ADDENDUM - *G6/*GF1 80+ TWO STAGE FURNACE WITH FIXED SPEED BLOWERS

7085110

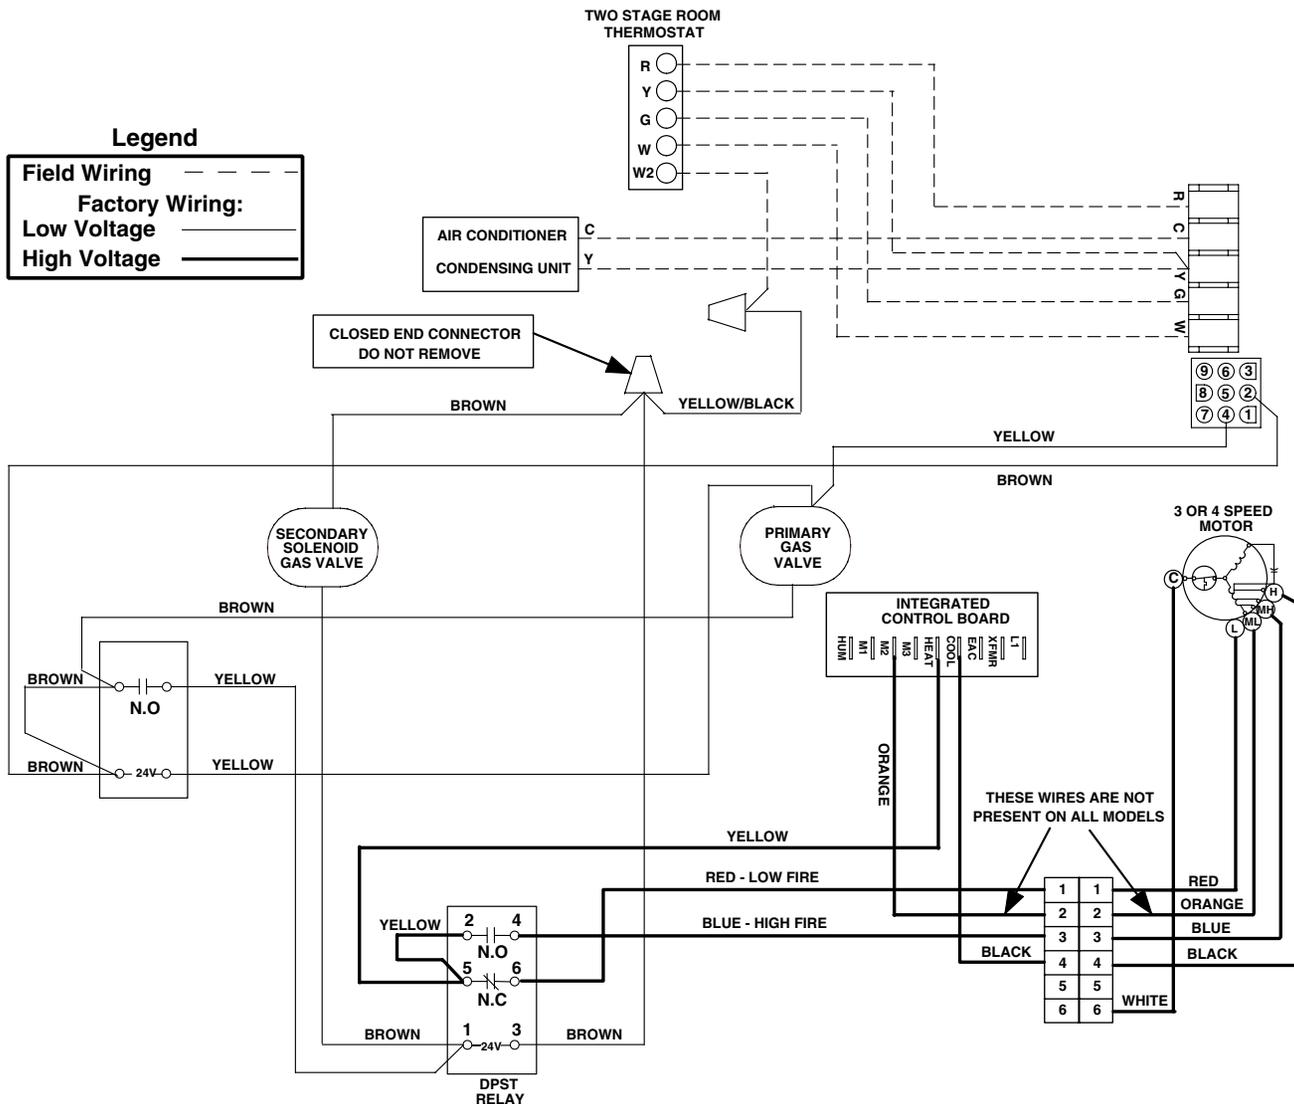
Figure numbers 23 and 26 in the Installation Instructions display improper wiring. The low fire blower speed wire should be placed on terminal #6 on the DPST blower relay, and the high fire blower speed wire should be placed on terminal #4. Refer to the drawing below, and Table 2 in the Installation Instructions for details.
